febi 14110

Vauxhall Corsa B, Tigra A, Astra F 1.4 16V and 1.6 16V, also Vectra B 1.6 16V and 1.8 16.V

Timing belt kit

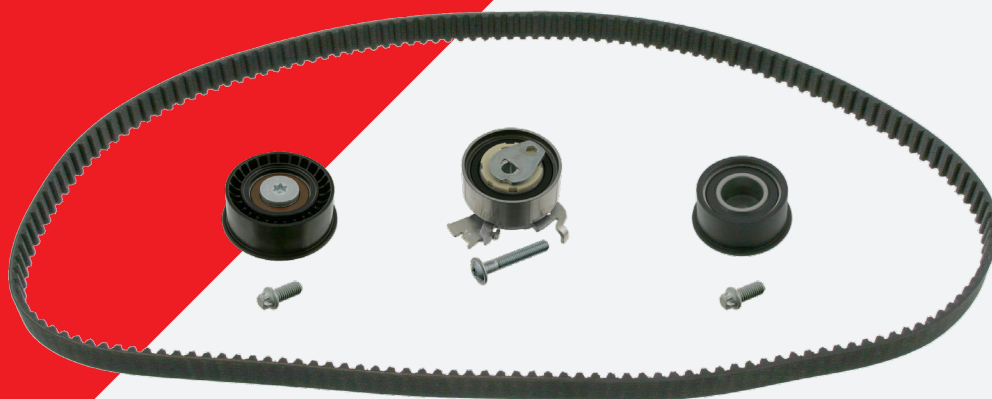
The design of the belt pulley has been changed by the vehicle manufacturer. The slightly raised section of the old belt pulley (refer to picture 1) can cause a faster deterioration of the timing belt edge. This causes the timing belt to move and be prematurely torn, leading to serious engine damage.

febi recommends: before fitting the timing belt kit febi 14110, check for a raised part of the belt pulley and, if necessary, replace with the new version (refer to picture 2) (Vauxhall plan 5614 430). The new belt pulley will fit correctly to the timing belt, thereby guaranteeing a longer life span.

Please note: when you replace the belt pulley, the crankshaft gear (refer to picture 3) (Vauxhall 0614 546) and the stretch bolt (refer to picture 4) (0614 932 Torx) should also be replaced.
